# Groundwater Application Review Summary Form

Application # G- 18705

GW Reviewer Joe Kemper Date Review Completed: 6/7/2021

TO: Water Rights Section Date 6/7/2021  
 FROM: Groundwater Section Joe Kemper  
Reviewer's Name  
 SUBJECT: Application G- 18705 Supersedes review of 5/16/2019  
Date of Review(s)

Figure 2. Well Location Map

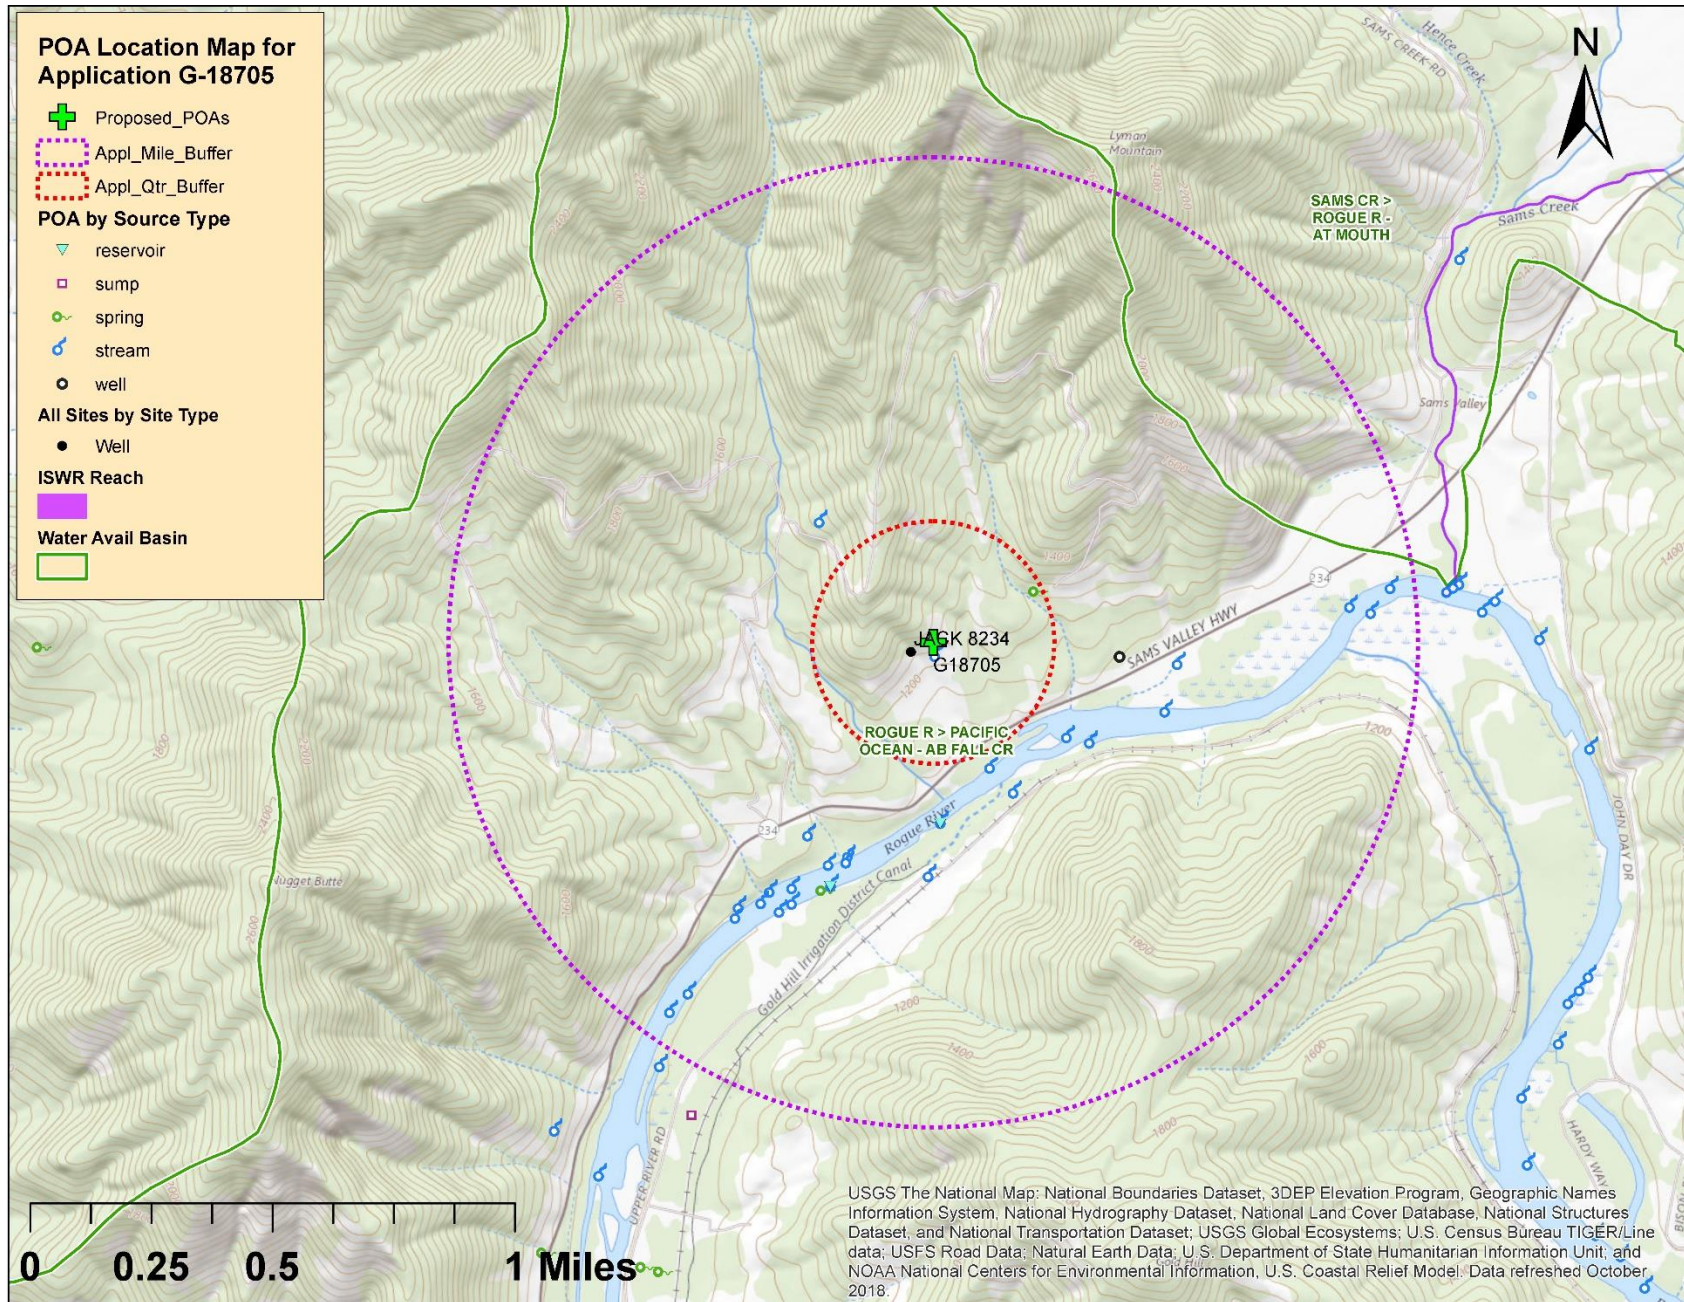
Well	Logid	Applicant's Well #	Proposed Aquifer*	Proposed Rate(cfs)	Location (T/R-S QQ-Q)	Location, metes and bounds, e.g. 2250' N, 1200' E fr NW cor S 36
1	Proposed	1	Bedrock	0.0334	36S/3W-11 NWNW	530'S, 620'E fr NW cor S 11*

A4. **Comments:** The amended application map removes JACK 8234 and adds a proposed well at the above location. This re-review evaluates that change.
